### Architectural Review Committee Staff Report Meeting Date: December 17, 2024

**PETITION:** StorAmerica Office Suites Building

**REQUEST:** Seeking approval of building design for an office building.

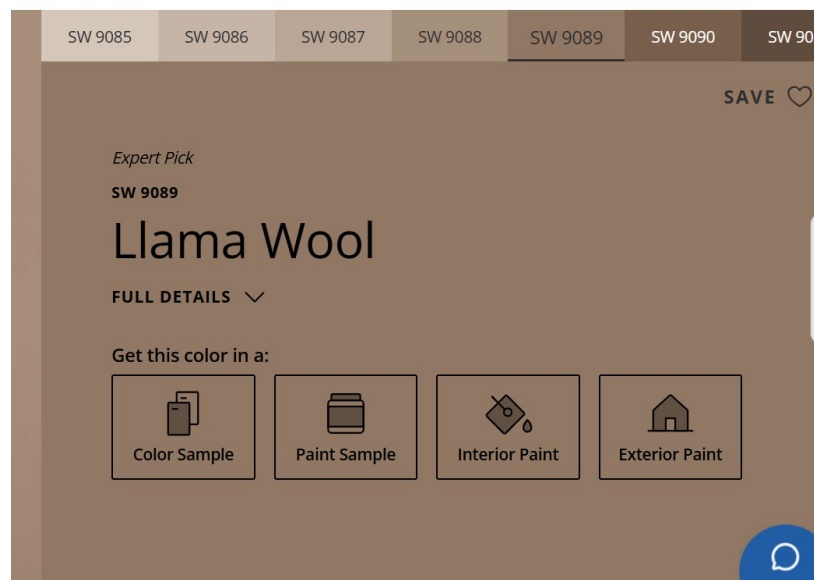
- The petitioner is proposing a screen for the RTUs and notes the screen will be tan. Staff would like clarification as to the material of the screen and see an example.

- Staff would like to see the stamp pattern of the cast stone being used as a wainscot. Additionally, the petitioner is proposing the cast stone color – Mahogany. This seems like a darker color and we would like to see how this color complicates the brick color selection.

- Decorative sconces are required at each entrance on the north façade. These sconces should be a smaller scale than the gooseneck sconces shown on the two-story portion of the building.

- The rear elevation is required to feature a minimum of 50% brick or stone. Staff would request that the 2-story portion be 100% brick or stone, since this will be visible above the self-storage building and then the remaining percentage of brick/stone can be placed as the petitioner needs to meet the requirement.

- The proposed drawings show brick or cast stone as the exterior siding materials, except for the east elevation of the 2nd floor and the rear elevation.
  - The rear elevation, as noted above in this report, does need added masonry material.
  - The east elevation of the 2nd floor is proposed as horizontal lap fiber cement siding. While this is a permitted material, the selection and placement of this material is a concern for staff. It does not appear to be consistent with the design of the north, east, and west facades. This is a significant departure from the main building design and staff is unsure of the design thought/intent behind this choice.
